MFN 08-454, Supplement 1

**Subject: Response to Portion of NRC Request for Additional Information  
Letter No. 321 Related to the ESBWR Design Certification –  
Containment Systems – RAI Number 6.2-98 S02**

**RAI Number 6.2-98 S02**

**LTR NEDE-33440P Markups**

RAI 6.2-98 S01 Figure 6.2-98 S01-2. DCD TRACG Nodalization of the ESBWR Containment

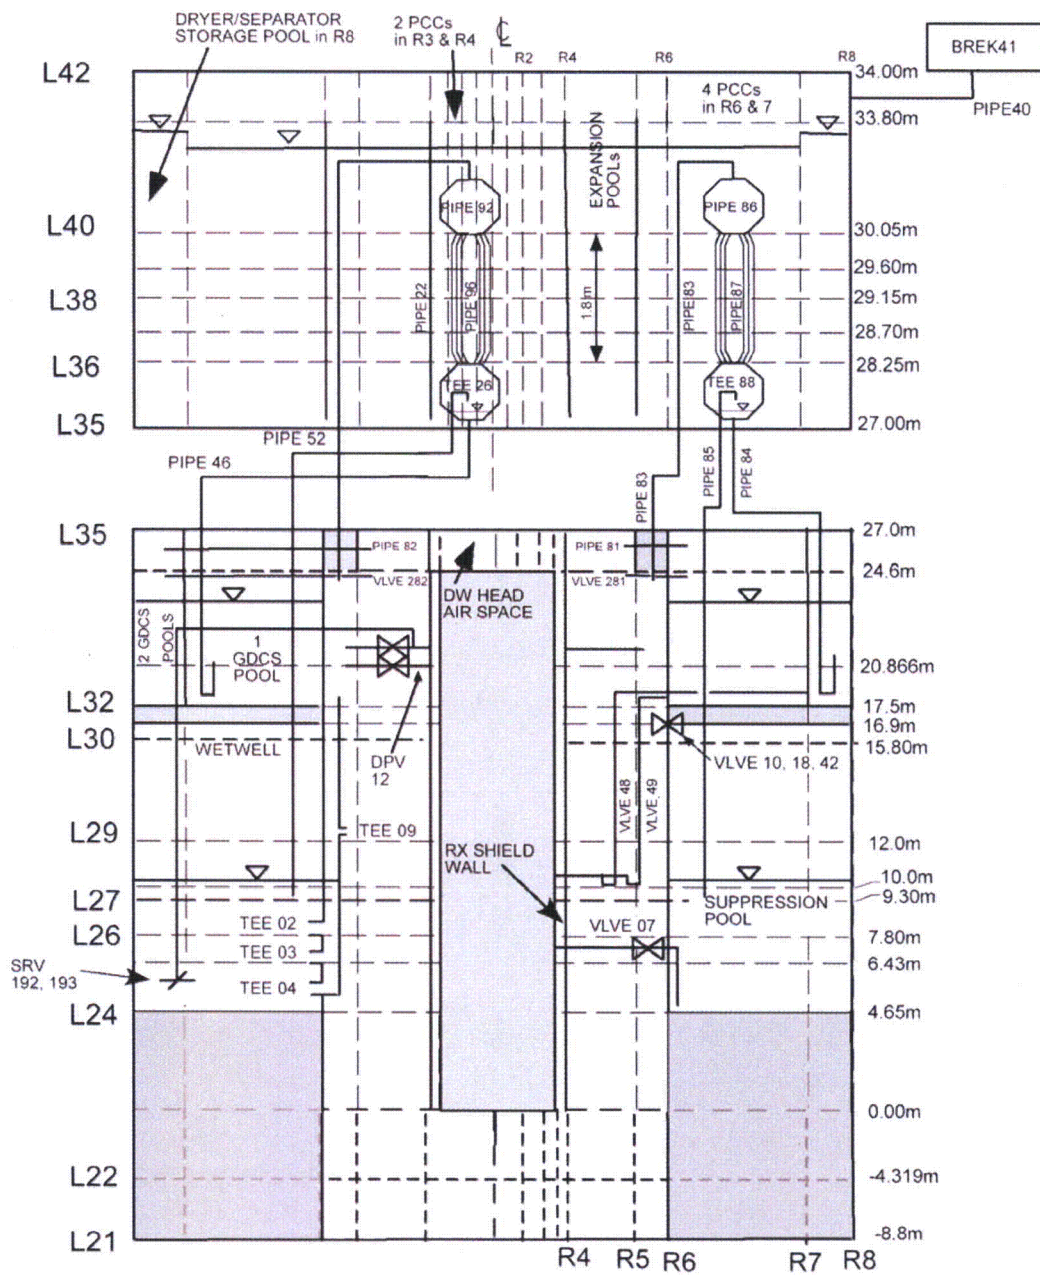
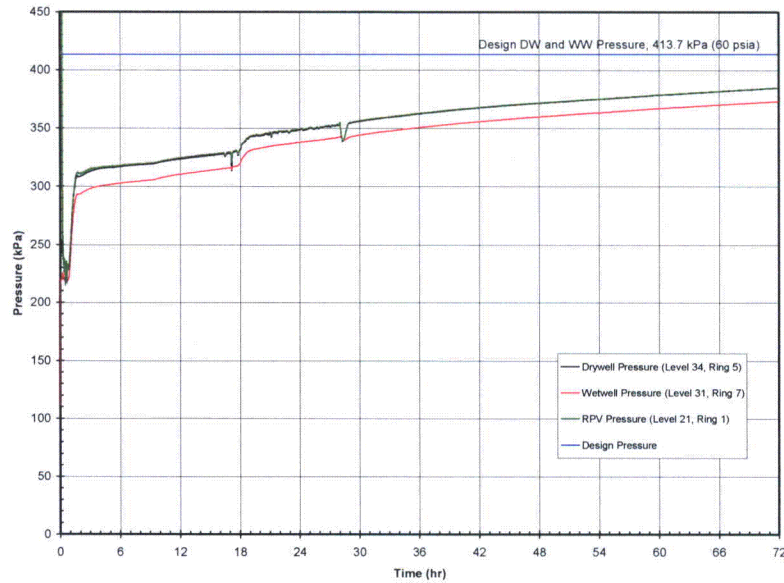
- (A) The limiting design basis accident changed from feed water line break (FWLB) to main steam line break (MSLB) as given in ESBWR DCD Tier 2 Revision 3. As a result, in RAI 6.2-141, the staff requested GEH to revisit RAIs that were affected by this change, specifically RAI 6.2-98. However, the GEH's response to RAI 6.2-98 was based only on the FWLB accident. The analyses results of the FWLB accident are important because of their closeness to that of the MSLB accident and the fact that FWLB is the second limiting accident. Please provide the analyses results of the MSLB accident.

Referring to the TRACG nodalization (Figures 6.2-98S01-1 and 6.2-98S01-2), the broken main steam line is located at Level 34 and discharges steam into the drywell (DW) at this elevation. Two pipes (per Gravity-Driven Cooling System (GDCS) airspace) are used to simulate the connection between the GDCS pool airspace and the DW (RAI 6.2-98 S01 Figure 6.2-98 S01-2), to purge the residual non-condensable (NC) gases in this airspace. For the NC gases, the nitrogen properties are used in these TRACG calculations.

Figures 6.2-98S01-1 and 6.2-98S01-2 show the TRACG nodalizations for the RPV and containment. DCD Tier 2, Revision 4, Figure 6.2-8b shows the nodalization for the feedwater line system. Two pipes (per GDCS airspace) are used to simulate the connection between the GDCS pool airspace and the DW (RAI 6.2-98 S01 Figure 6.2-98 S01-2), to purge the residual NC gases in this airspace. For the NC gases, the nitrogen properties are used in these TRACG calculations.

Two pipes (per GDCS airspace) are used to simulate the connection between the GDCS pool airspace and the DW (RAI 6.2-98 S01 Figure 6.2-98 S01-2). This nodalization is selected to minimize the NC gas holdup in the DW head and GDCS pool airspaces. Parametric studies (using MSLB case) were performed earlier (response to RAI 6.2-53 S01, MFN 02-215, Supplement 1) to evaluate the effectiveness of the double pipe connection. The results show that there are essentially no NC gases remaining in the DW head and GDCS airspaces for the MSLB with double pipe connection. The current results (Paragraph A1.4 in this response) also show the same effect on the purging of NC gases.

The two pipes are connected at the top two axial levels in the GDCS airspace (L35 and L34, RAI 6.2-98 S01 Figure 6.2-98 S01-2), one pipe per level (per GDCS airspace). For MSLB, in which case the GDCS pool level stays above L33 (i.e., no air mass is stored in L33), the two-pipe model works effectively to purge the NC gas masses stored in the top two levels to minimal values in a few hours. For breaks other than MSLB, the GDCS pool levels drop into L33 (the pool level is approximately 6 meters below the lower connection pipes) during the draindown period and a small amount of NC gas mass remains in this bottom level. Since the pressure margins for the non-MSLB breaks are more than 10% higher than that for the MSLB (DCD Tier 2, Revision 4, Table 6.2-5), this small amount of NC gas remaining in the GDCS airspace for non-MSLB breaks would not change the conclusion that MSLB is the limiting break.

**RAI 6.2-98 S01 Figure 6.2-98 S01-13. GDCS Pool Airspace NC Gas Pressures  
(72 Hours)  
(MSLB: MSL4A\_1DPVCB-72)**

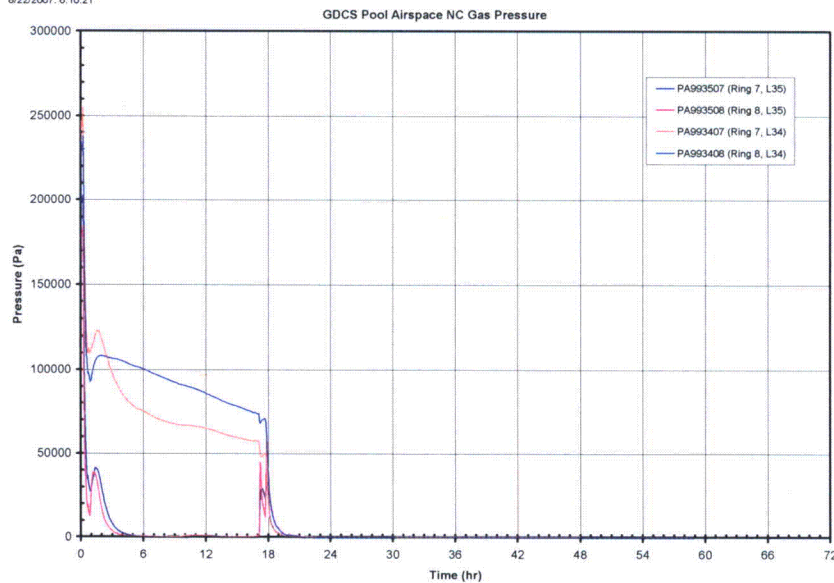
- (C) As shown on Figure 6.2-98-5, the noncondensable gas holdup in the drywell head region at 72 hours resulting in a pressure of 50 KPa is significant. Please (1) provide the mass of noncondensables held up in the drywell head region and (2) quantify the effect on the drywell pressure, if the noncondensables held up in the drywell head and GDSCS pools were transferred to the wetwell.

RAI 6.2-98 S01 Figure 6.2-98 S01-9 through RAI 6.2-98 S01 Figure 6.2-98 S01-13 show the NC gas pressures in the DW annulus, lower DW, air gap between the RPV and the reactor shield wall, the DW head airspace, and the GDCS pool airspace. Most of the initial NC gases in the DW annulus are purged into the WW within 3 hours. It takes approximately 24 hours to purge most of the NC gases in the DW head airspace (RAI 6.2-98 S01 Figure 6.2-98 S01-12). It takes approximately 20 hours to purge most of the NC gases in the GDCS pool airspaces (RAI 6.2-98 S01 Figure 6.2-98 S01-13).

**RAI 6.2-98 S01 Figure 6.2-98 S01-46. Comparison of DW Pressures – MSLB versus FWLB (72 Hours)**

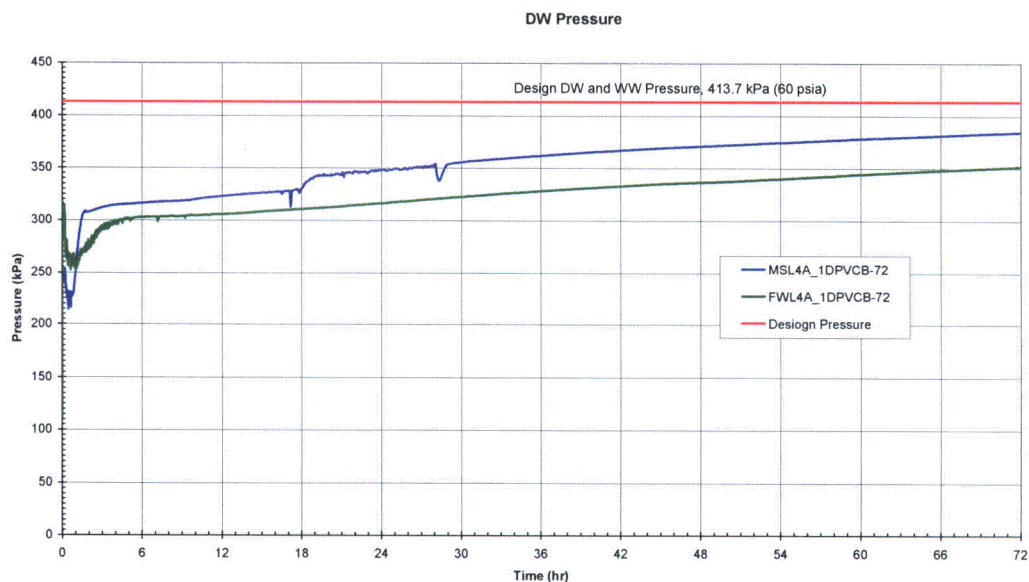
- (D) After the opening of the DPVs, the long-term containment responses from FWLB accident to MSLB accidents are expected to be similar. However, the results show that they differ. Please (1) identify and justify the nodalization differences between FWLB and MSLB accidents and (2) explain the differences in results.

(D) After the opening of the DPVs, the long-term containment responses from FWLB accident to MSLB accidents are expected to be similar. However, the results show that they differ. Please (1) identify and justify the nodalization differences between FWLB and MSLB accidents and (2) explain the differences in results.

RAI 6.2-98 S01 Figure 6.2-98 S01-46 compares the DW pressures from these two cases. For the MSLB case, essentially all NC gases remaining in the DW head and GDCS airspaces (Paragraph A1.4) are purged into the WW after 20 hours. The calculated DW pressure in the MSLB case accounts for the effect that all NC gases have been purged into the WW. After 20 hours, the calculated DW pressures from these two cases are very similar in trend. The DW pressure in the MSLB case is higher than that in the FWLB case. The pressure difference is more or less constant through out the rest of the transient.

31.7 kPa. Accounting for this combined effect, the calculated DW pressure in the FWLB case agree very well with that calculated in the MSLB case.

**RAI 6.2-98S01R01 Figure 6.2-98S01R01-1. Pressure Responses in DW and WW**

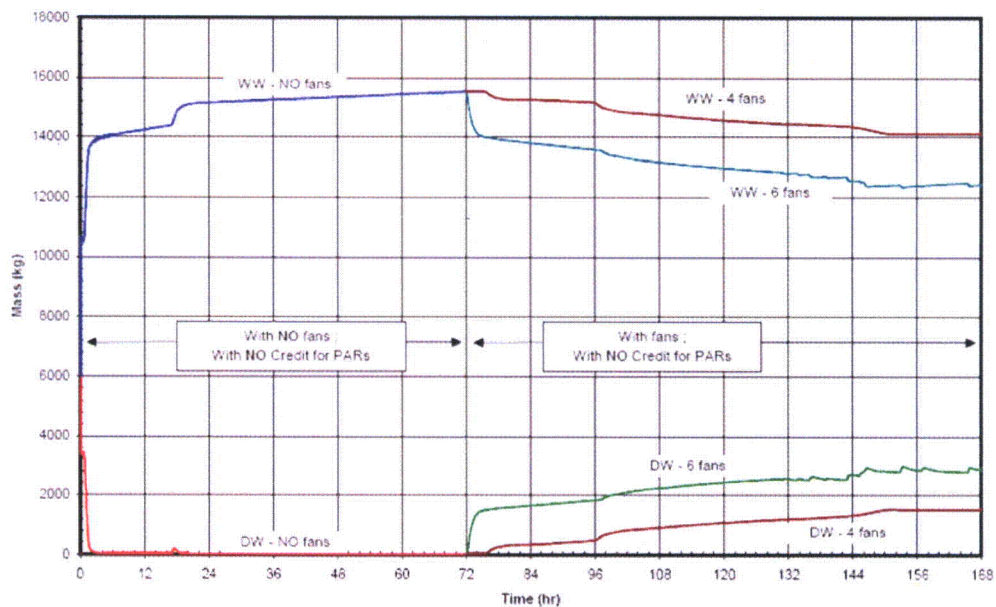
- (E) During a phone call with the staff on September 24, 2007, GEH discussed a potential design change to add a drywell gas recirculation system to the PCCS, which will start operating three days after the initiation of a LOCA to improve the PCCS's ability to remove thermal energy from the containment. In your response, please address the effect of the drywell gas recirculation system and any other systems that you plan to credit in your analyses.

RAI 6.2-98S01R01 Figure 6.2-98S01R01-1 and RAI 6.2-98S01R01 Figure 6.2-98S01R01-2 show the pressure and NC gas mass responses in the DW and WW from 0 to seven days (0 to 168 hours). RAI 6.2-98S01R01 Figure 6.2-98S01R01-3 shows the NC gas mass responses in the DW head and GDCS gas spaces from 0 to seven days (0 to 168 hours).

The key transient responses from 0 to 72 hours are discussed in Item (A1) of the response to RAI 6.2-139 (MFN 08-357, dated April 19, 2008). During the first three days of the transient, the IC/PCC pool level drops due to boil-off by the decay heat. At the end of 72 hours, the IC/PCC pool water covers about 65% of the PCC condenser tube length. At 72 hours, the PCC vent fans and the IC/PCC pool refilling are initiated. The PCC vent fans remove the accumulated NC gases from the bottom portion of the PCC condenser tubes and discharge them into the DW. The IC/PCC pool refilling continuously increases the portion of the PCC condenser tube that is covered by the IC/PCC pool water. Both actions enhance the PCC condenser heat removal rate, condensing more DW steam. As a result, the DW pressure drops rapidly shortly after the activation of these actions (RAI 6.2-98S01R01 Figure 6.2-98S01R01-1). Shortly after 72 hours, the DW pressure drops below the WW pressure, resulting in vacuum breaker (VB) openings and reversed leakage flow (i.e., from the WW to the DW). The gas mixture (mostly NC gases) flows back from the WW to the DW through the VBs and leakage path (RAI 6.2-98S01R01 Figure 6.2-98S01R01-4). This continued relocation of NC gases from the WW to the DW results in continued pressure reduction in the WW (RAI 6.2-98S01R01 Figure 6.2-98S01R01-1).
